HISTORIC AND DESIGN REVIEW COMMISSION

March 16, 2022

HDRC CASE NO: 2022-121
ADDRESS: 535 E HUISACHE AVE
LEGAL DESCRIPTION: NCB 3090 BLK 6 LOT 28
ZONING: R-4, H
CITY COUNCIL DIST.: 1
DISTRICT: Monte Vista Historic District
APPLICANT: CEE WINKLER/WINKLER JULIE M
OWNER: WINKLER JULIE M
TYPE OF WORK: Front walkway modifications
APPLICATION RECEIVED: February 17, 2022
60-DAY REVIEW: Not applicable due to City Council Emergency Orders
CASE MANAGER: Hannah Leighner

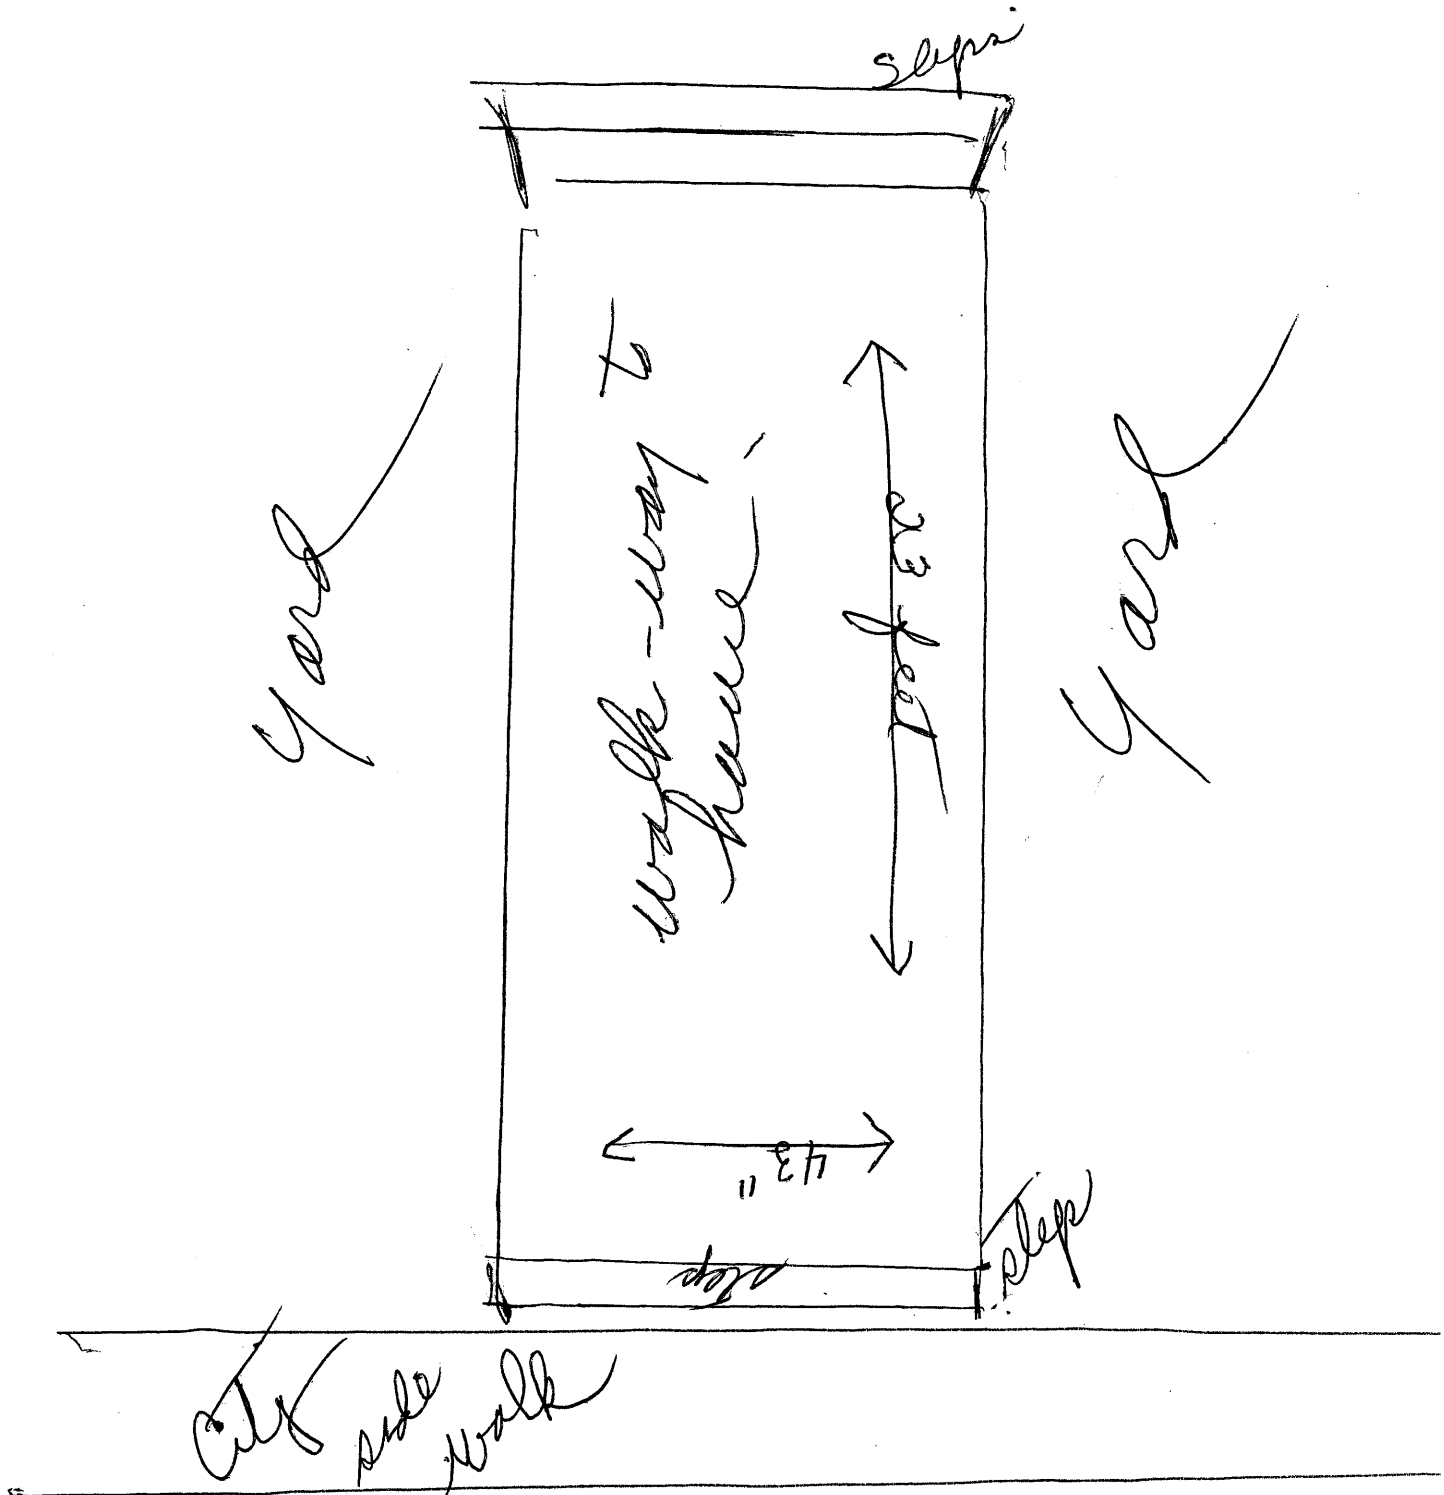
- c. **SIDEWALK REPLACEMENT** – The applicant is proposing to replace the existing poured concrete walkway and front steps with set and grouted flagstone pavers. The property is located on the 500 block of E Huisache Avenue, which maintains properties which feature poured concrete driveways and front walkways that are in similar profile and color to the existing sidewalks which run along the north and south sides of E Huisache. The Guidelines for Site Elements 5.A.i-iii state that historic sidewalks should be replaced only where beyond repair using in-kind materials, and to match the existing sidewalk in material composition and color, width, and alignment. Staff finds the replacement sidewalk to be inconsistent with these guidelines. Replacement with a poured concrete sidewalk that matches the original sidewalk would be appropriate.

Staff does not recommend approval for sidewalk replacement based on finding b. Staff recommends that the applicant install a poured concrete sidewalk that is consistent in material, dimension, profile, and color to that which was removed, and that is consistent with sidewalks that are found historically on the block.
